**SUSQUEHANNA STEAM ELECTRIC STATION  
UNITS 1 AND 2 LICENSE RENEWAL APPLICATION (LRA)  
STATION BLACKOUT SCOPE ADDITION  
PLA-6362**

**Docket Nos. 50-387  
and 50-388**

**Attachment to PLA-6362**  
**SBO Scope Addition**  
**Revised LRA Sections 2.2, 2.4, 2.5, 3.5, 3.6**

**Figure 2.5-1**  
**Graphical Representation of the SSES SBO License Renewal Boundary**

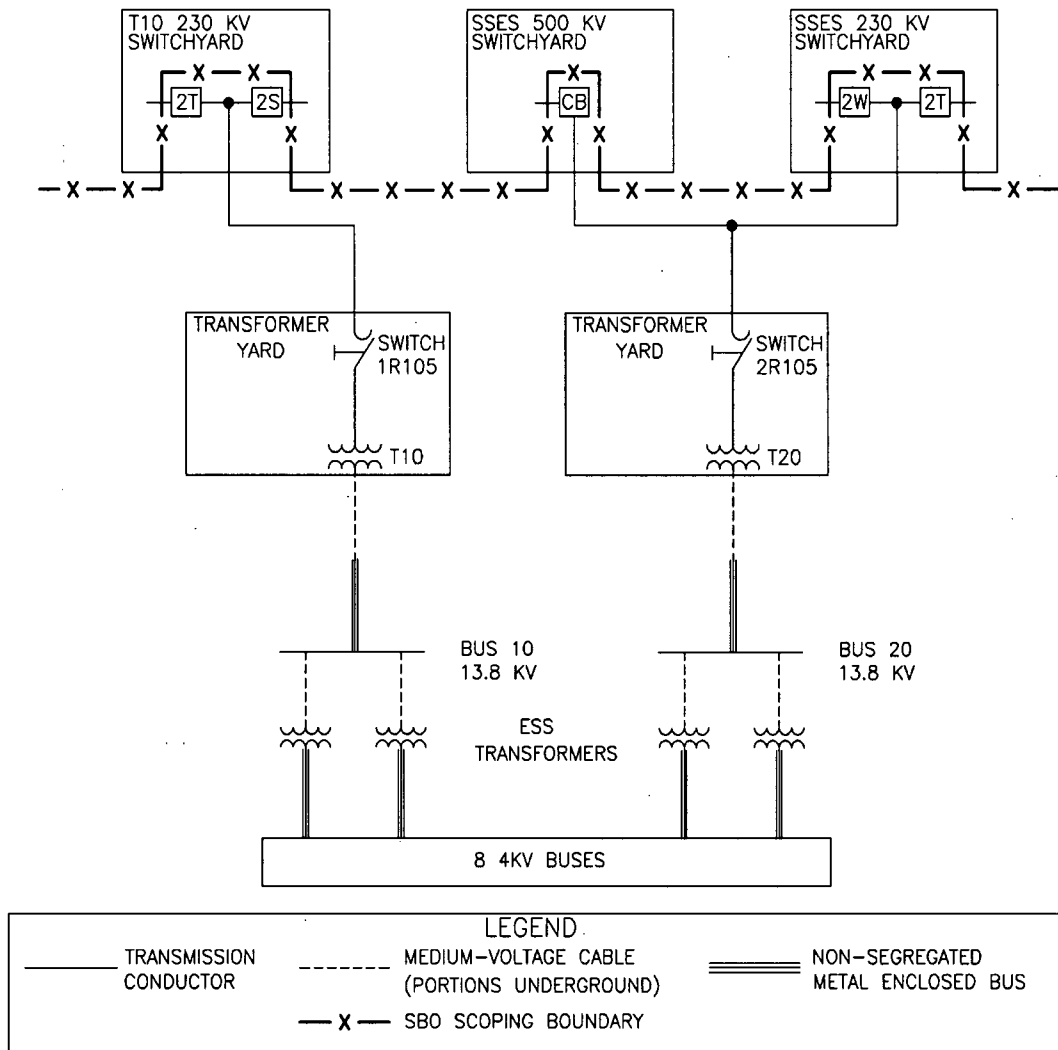
- The following figure under Section 2.5.6.2 (on LRA page 2.5-10) is replaced. The text associated with Figure 2.5-1 (on LRA page 2.5-10) is revised by addition (bold italics) and deletion (strikethrough).

As is shown *at the top of this figure*, the **SBO LR scoping boundary is at circuit breakers located in the three switchyards**. ~~connection to the grid is made in the transformer yards at switches 1R105 and 2R105. All of the 230 kV components in the plant portion of the offsite power system are listed in the plant's equipment database as part of the 13.8 kV electrical system.~~
